**Regulation No. 99 (Gas-discharge light sources)**

### **Proposal for Supplement 7 to Regulation No. 99**

#### **Submitted by the expert from Society of Automotive Engineers\***

The text reproduced below was prepared by the expert from the Society of Automotive Engineers (SAE) to introduce a new category of gas discharge light source D7S in the regulation. The proposal is in addition to ECE/TRANS/WP.29/GRE/2011/3. The modifications to the existing text of the Regulation are marked in bold for new characters.

Figure 1  
Category D7S - Cap PK32d-1

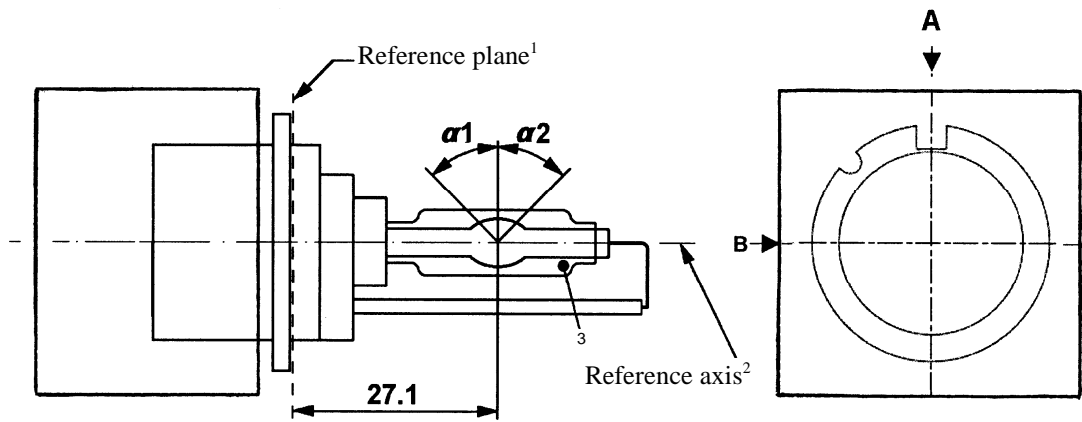
*Insert new sheets D7S/1 to 5 after D6S/5, to read:*

- 1 The reference plane is defined by the positions on the surface of the holder on which the three supporting bosses of the cap ring will rest.
- 2 See sheet D7S/2.
- 3 When measured at a distance of 27.1 mm from the reference plane and with respect to the mid-point of the inner bulb, the outer bulb shall have an eccentricity of 1 mm max.

Figure 2  
Definition of reference axis<sup>1</sup>

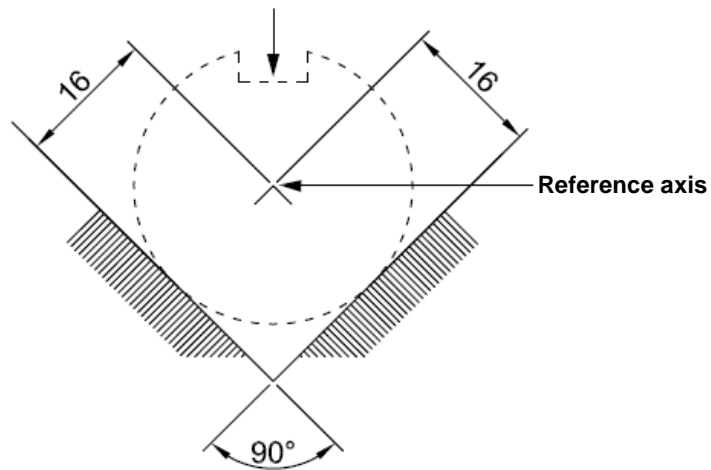
- <sup>1</sup> The reference axis is perpendicular to the reference plane and crosses the intersection of the two parallel lines as indicated in figure 2.
- <sup>2</sup> Glass bulb and supports shall not exceed the envelope, as indicated in figure 3. The envelope is concentric with the reference axis.

Position of the electrodes

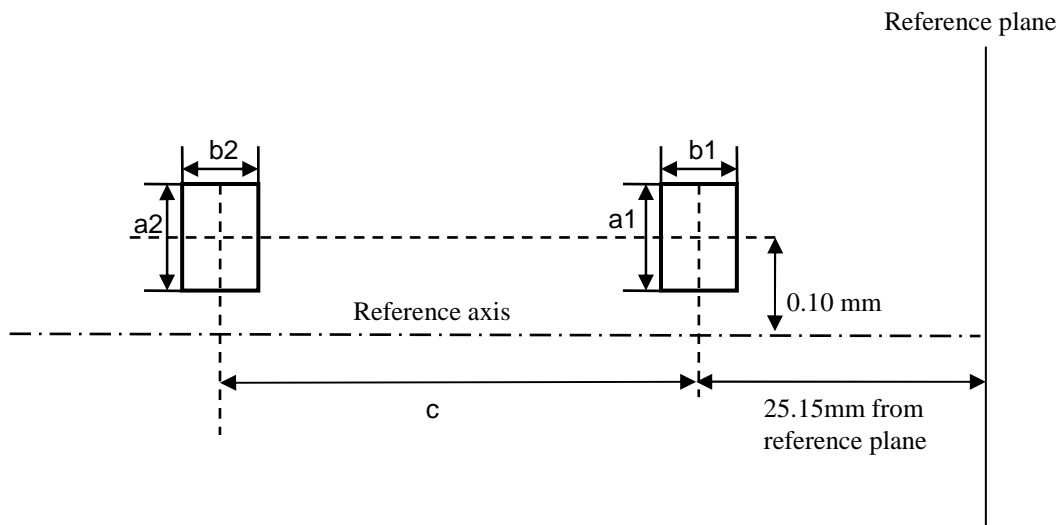
This test is used to determine whether the electrodes are correctly positioned relative to the reference axis and the reference plane.

The arc attachment point to the electrode nearest to the reference plane shall be positioned in the area defined by a1 and b1. The arc attachment point to the electrode furthest from the reference plane shall be positioned in the area defined by a2 and b2.

Position and form of the arc

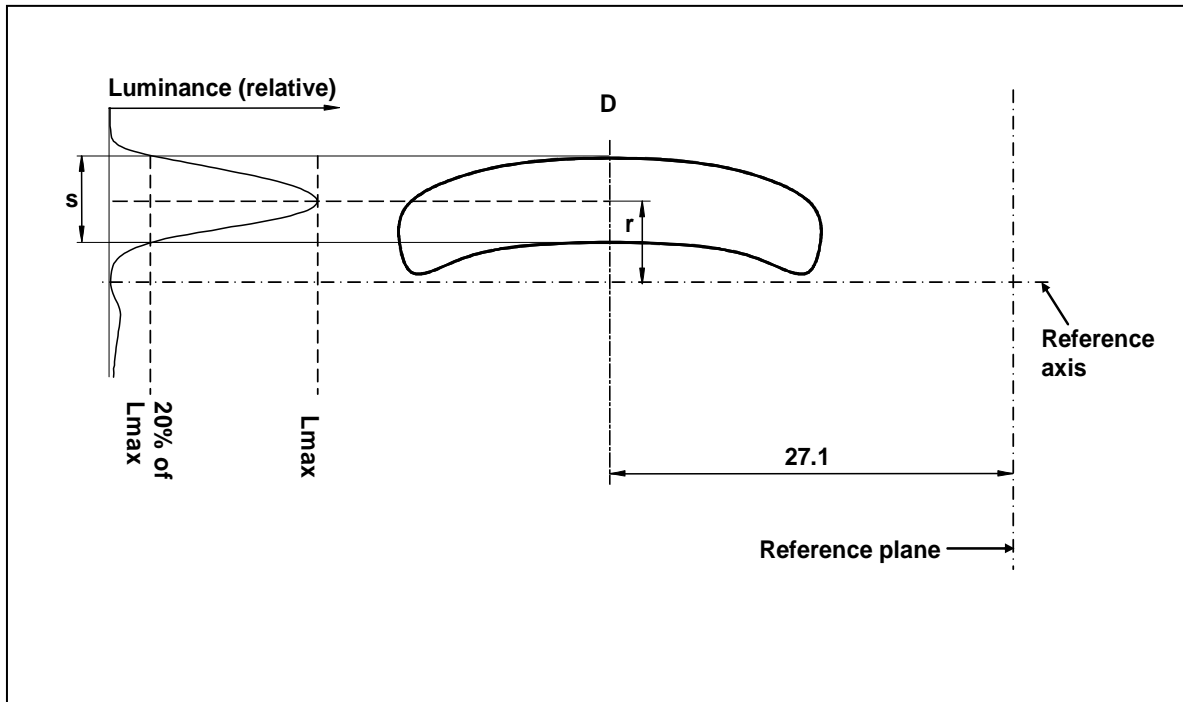
This test is used to determine the form of the arc and its position relative to the reference axis and the reference plane by measuring its bending and diffusion in the cross section at a distance 27.1 mm from the reference plane.

When measuring the relative luminance distribution in the central cross section as indicated in the drawing above, the maximum value shall be located within the distance r from the reference axis. The point of 20 per cent of the maximum value shall be within s.
